TRANS/WP.29/2001/25

PROPOSAL FOR DRAFT SUPPLEMENT 1 TO THE 01 SERIES
OF AMENDMENTS TO REGULATION No. 94

(Frontal collision protection)

Transmitted by the Working Party on Passive Safety (GRSP)

Figure 1

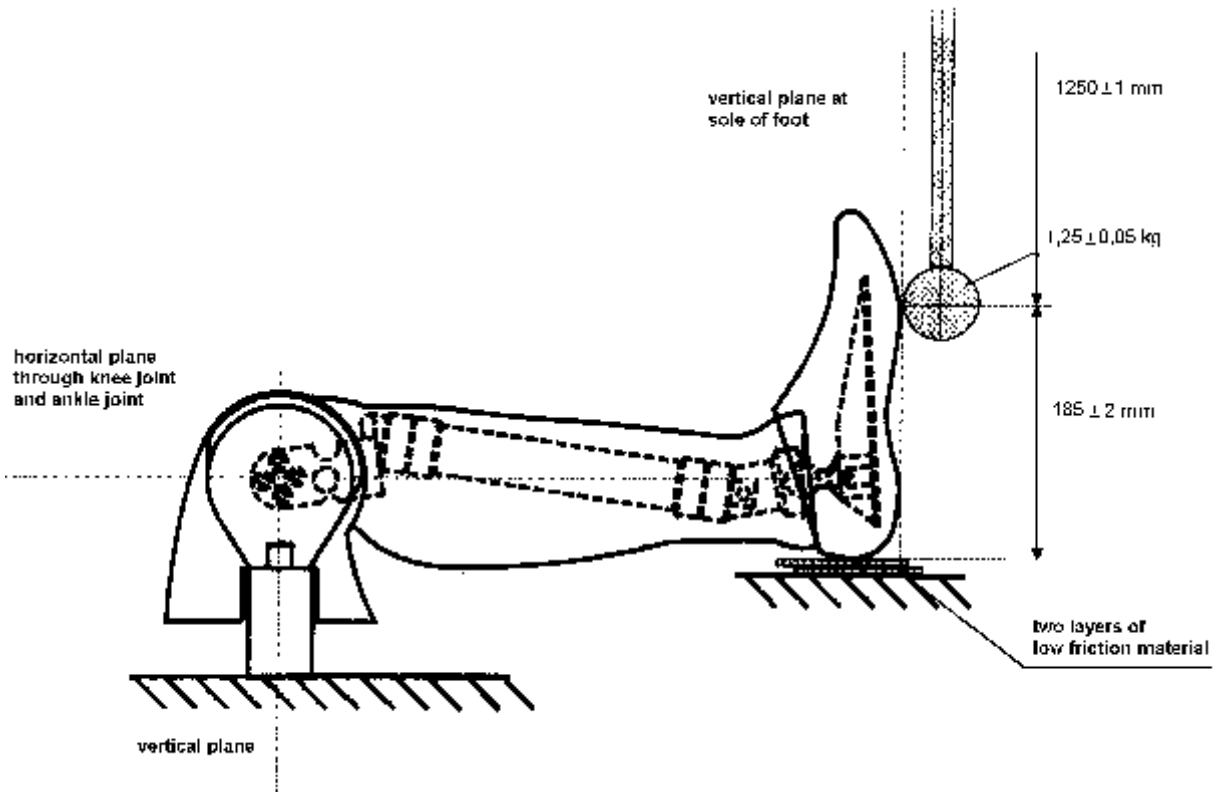
- 1.3.4. Mount the leg assembly to the fixture shown in Figure 1. The test fixture shall be rigidly secured to prevent movement during impact. The centre line of the femur load cell simulator (78051-319) shall be vertical with a tolerance of $\pm 0.5\text{E}$. Adjust the mount such that the line joining the knee clevis joint and the ankle attachment bolt is horizontal with a tolerance of $\pm 3\text{E}$, with the heel resting on two sheets of a flat low friction (PTFE sheet) surface. Ensure that the tibia flesh is located fully towards the knee end of the tibia. Adjust the ankle such that the plane of the underside of the foot is vertical and perpendicular to the direction of impact with a tolerance of $\pm 3\text{E}$ and such that the mid sagittal plane of the foot is aligned with the pendulum arm. Adjust the knee joint to 1.5 ± 0.5 g range before each test. Adjust the ankle joint so that it is free and then tighten just sufficiently to keep the foot stable on the PTFE sheet.

- 1.4. Performance specification
 - 1.4.1. When each ball of the foot is impacted at $6.7 (\pm 0.1)$ m/s in accordance with paragraph 1.3., the maximum lower tibia bending momentum about the y-axis (M_y) shall be 120 ± 25 Nm.

Figure 2

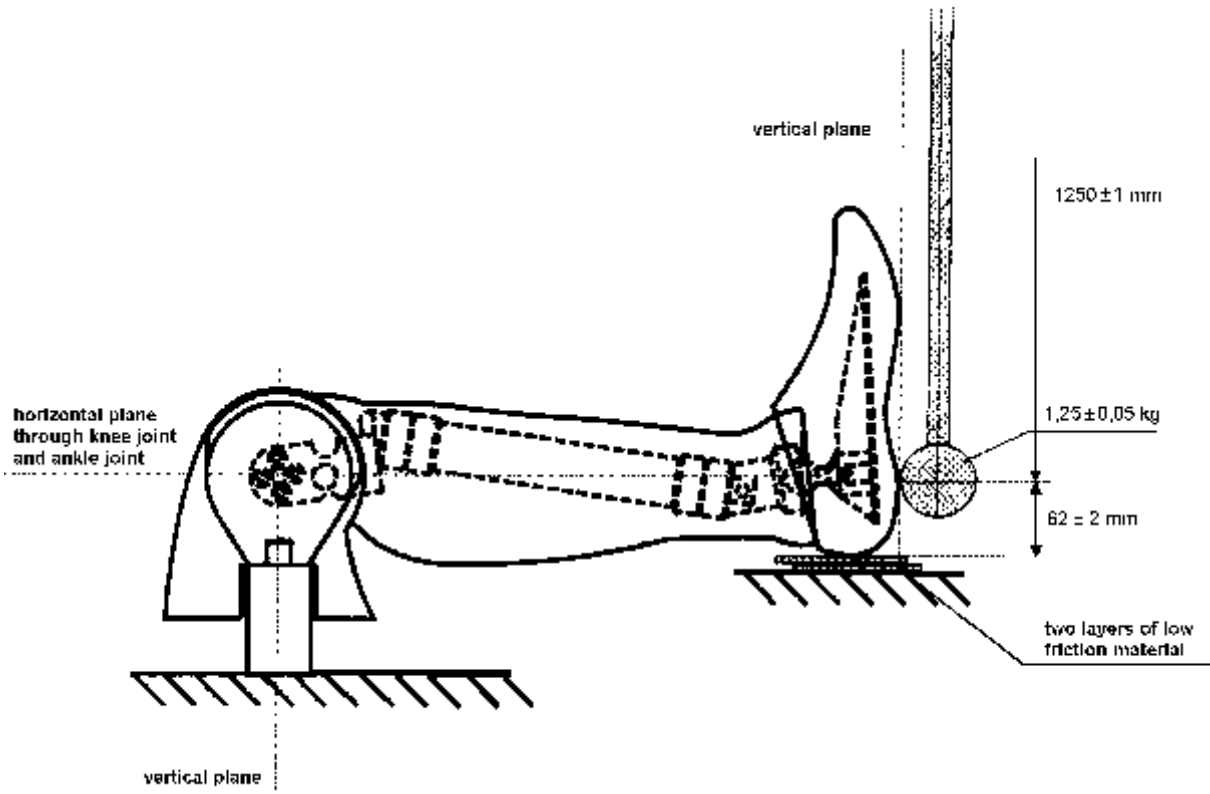
- 2.3.3. Align the impactor accelerometer with its sensitive axis parallel to the impactor longitudinal centre line.
- 2.3.4. Mount the leg assembly to the fixture shown in Figure 2. The test fixture shall be rigidly secured to prevent movement during impact. The centre line of the femur load cell simulator (78051-319) shall be vertical with a tolerance of ± 0.5 °. Adjust the mount such that the line joining the knee clevis joint and the ankle attachment bolt is horizontal with a tolerance of ± 3 ° with the heel resting on two sheets of a flat low friction (PTFE sheet) surface. Ensure that the tibia flesh is located fully towards the knee end of the tibia. Adjust the ankle such that the plane of the underside of the foot is vertical and perpendicular to the direction of the impact with a tolerance of ± 3 ° and such that the mid sagittal plane of the foot is aligned with the pendulum arm. Adjust the knee joint to 1.5 ± 0.5 g range before each test. Adjust the ankle joint so that it is free and then tighten just sufficiently to keep the foot stable on the PTFE sheet.

- 2.4. Performance specification
 - 2.4.1. When each heel of the foot is impacted at 4.4 ± 0.1 m/s in accordance with paragraph 2.3., the maximum impactor acceleration shall be 295 ± 50 g.

Figure 3

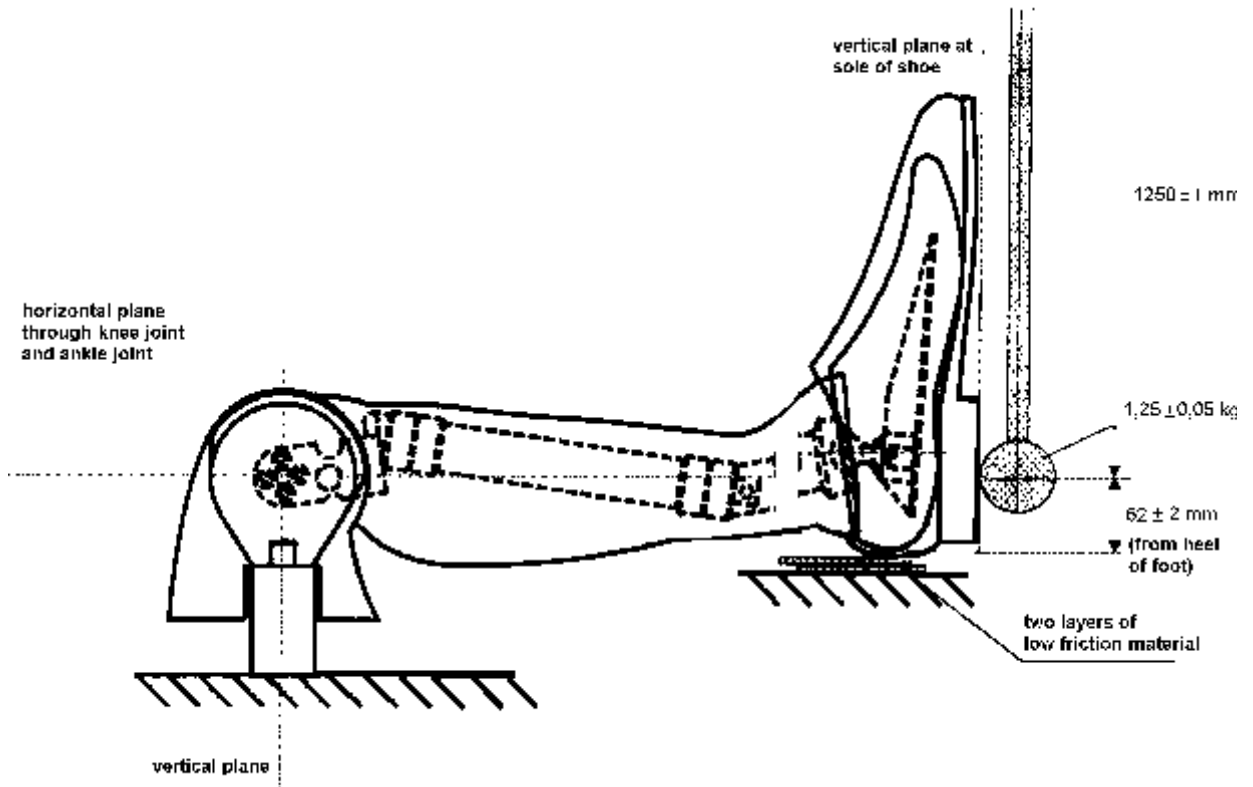
- 3.3.3. Align the impactor accelerometer with its sensitive axis parallel to the impactor longitudinal centre line.
 - 3.3.4. Mount the leg assembly to the fixture shown in Figure 3. The test fixture shall be rigidly secured to prevent movement during impact. The centre line of the femur load cell simulator (78051-319) shall be vertical with a tolerance of $\pm 0.5^\circ$. Adjust the mount such that the line joining the knee clevis joint and the ankle attachment bolt is horizontal with a tolerance of $\pm 3E$, with the heel of the shoe resting on two sheets of a flat low friction (PTFE sheet) surface. Ensure that the tibia flesh is located fully towards the knee end of

the tibia. Adjust the ankle such that a plane in contact with the heel and sole of the underside of the shoe is vertical and perpendicular to the direction of impact with a tolerance of $\pm 3^\circ$ and such that the mid sagittal plane of the foot, and shoe is aligned with the pendulum arm. Adjust the knee joint to 1.5 ± 0.5 g range before each test. Adjust the ankle joint so that it is free and then tighten just sufficiently to keep the foot stable on the PTFE sheet.

- 3.4. Performance specification
 - 3.4.1. When the heel of the shoe is impacted at 6.7 ± 0.1 m/s in accordance with paragraph 3.3, the maximum Tibia compressive force (F_z) shall be 3.3 ± 0.5 kN.
